Subject: Technical Revision (TR-09) to Gillette Sand & Gravel, Inc. Permit No. M-1992-009

## **EXHIBIT D - Technical Revision 09 to Exhibit D of the Mining Plan**

PROJECT: GILLETTE PONDS

Exhibit D Showing Sediment Pond,  
Crusher and Wash Plant Area

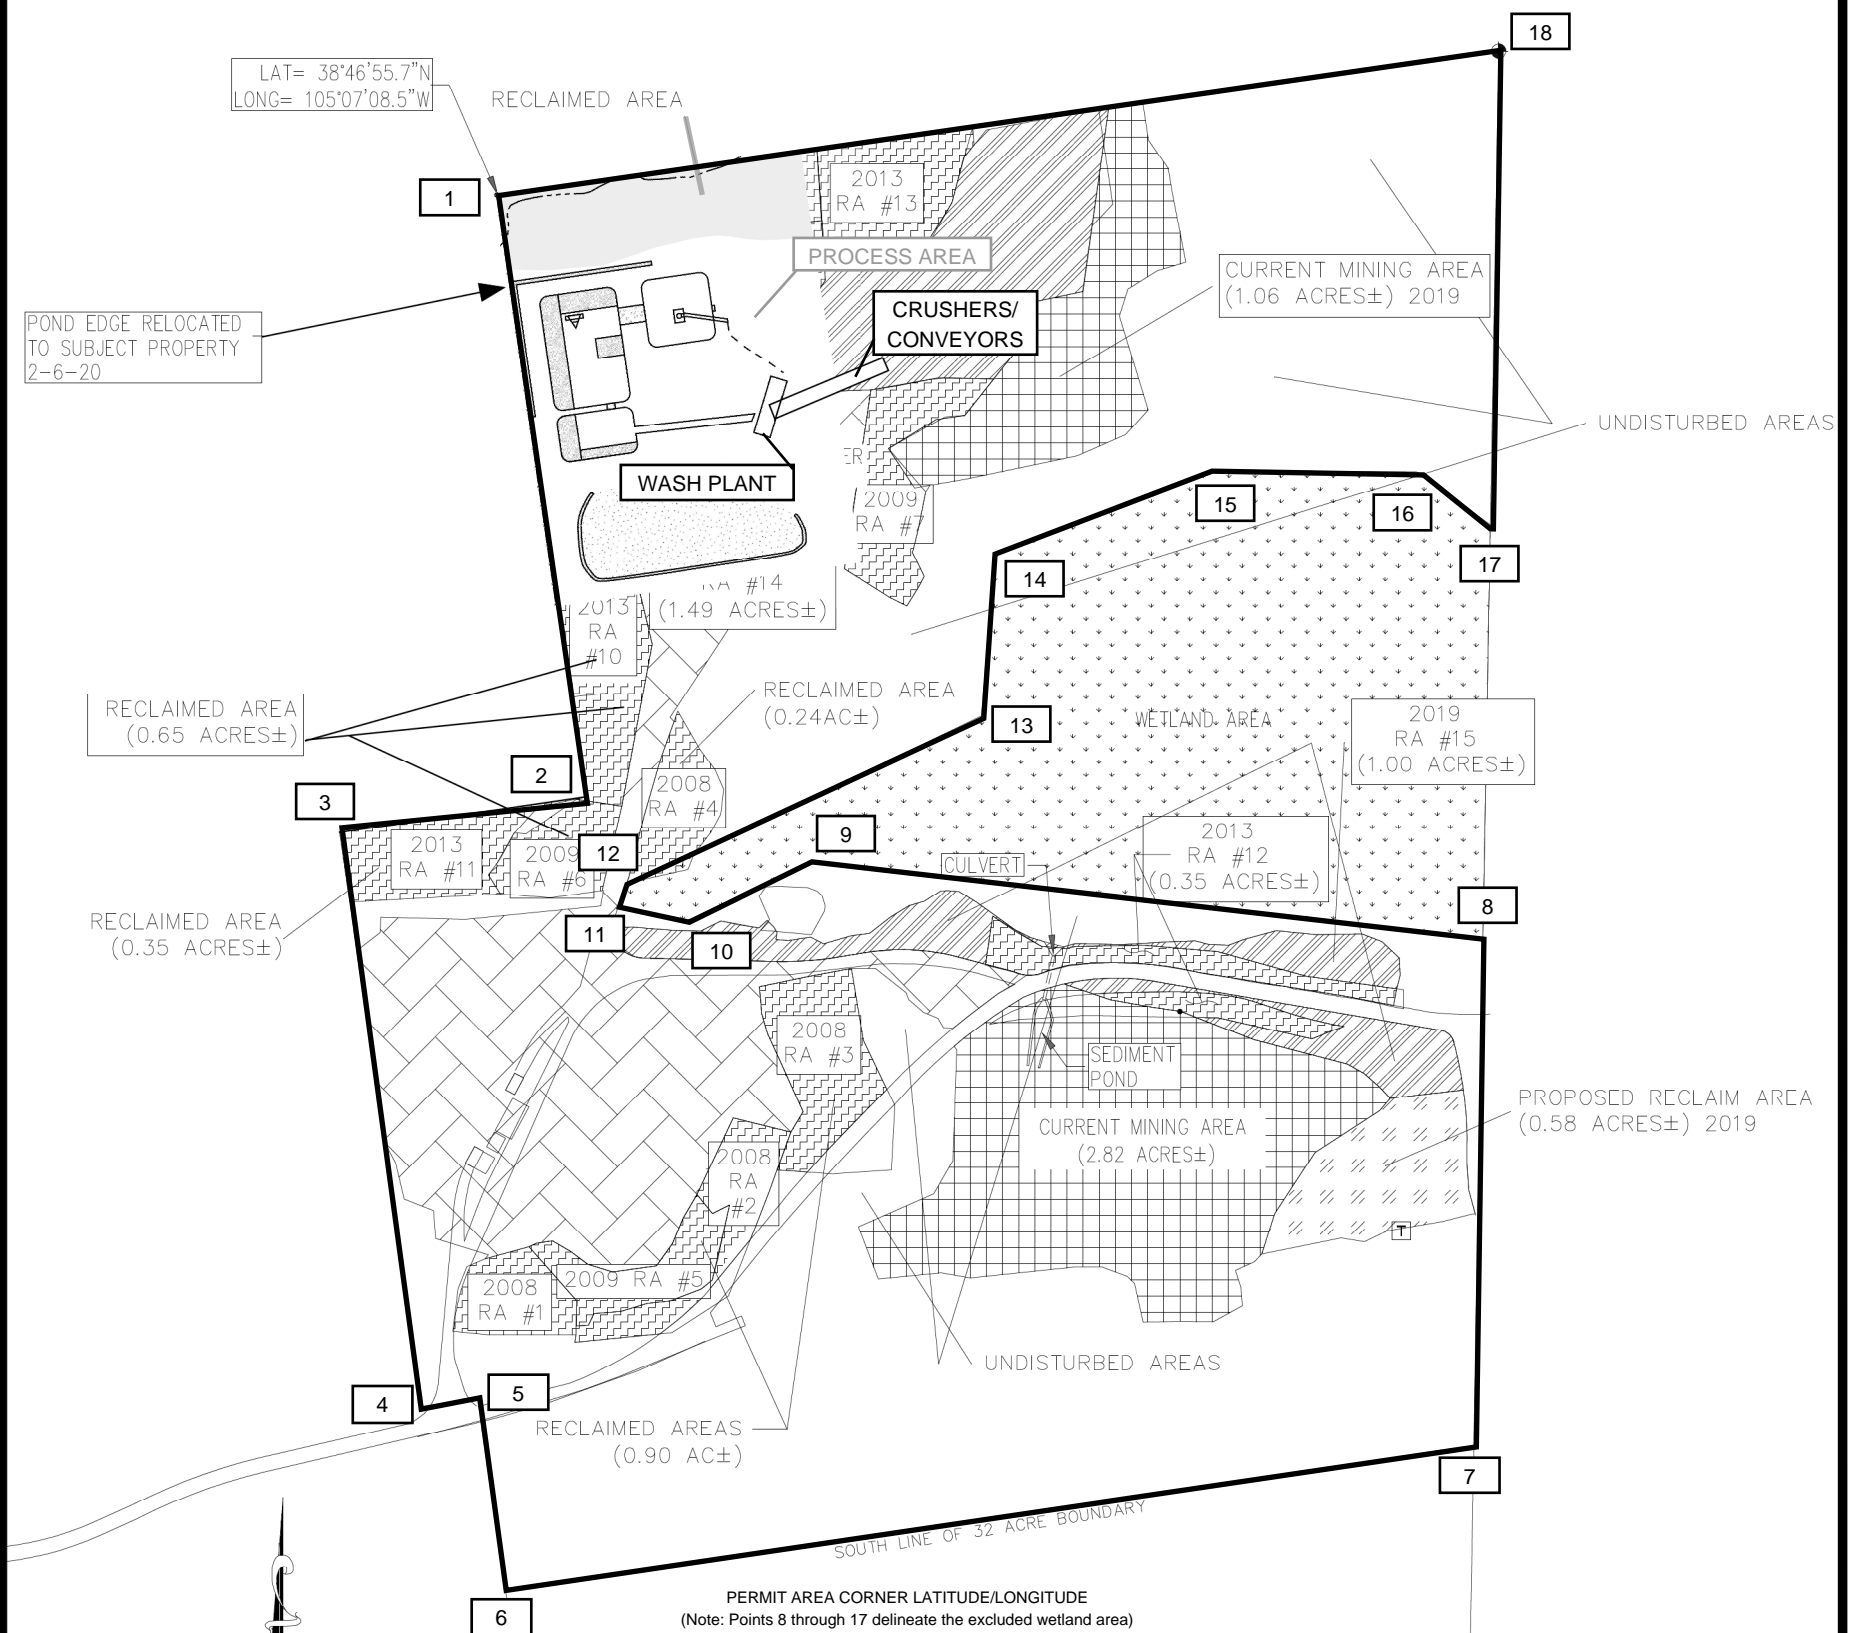
This Technical Revision (TR) has been prepared as an addendum to Exhibit D of the Department of Reclamation, Mining and Safety (DRMS), Permit No. M-1992-009. Changes to the existing mining plan include use of the existing crusher/wash plant in the process area.

Unless classification is performed at the extraction site by a portable crusher or screen plant, the central plant will be used for gravel sorting and washing. Part of this process will require crushing operations. If washing is required, it will also be performed at the central plant. The plant location is to the east of the settlement ponds and is shown in the attached Exhibit D.
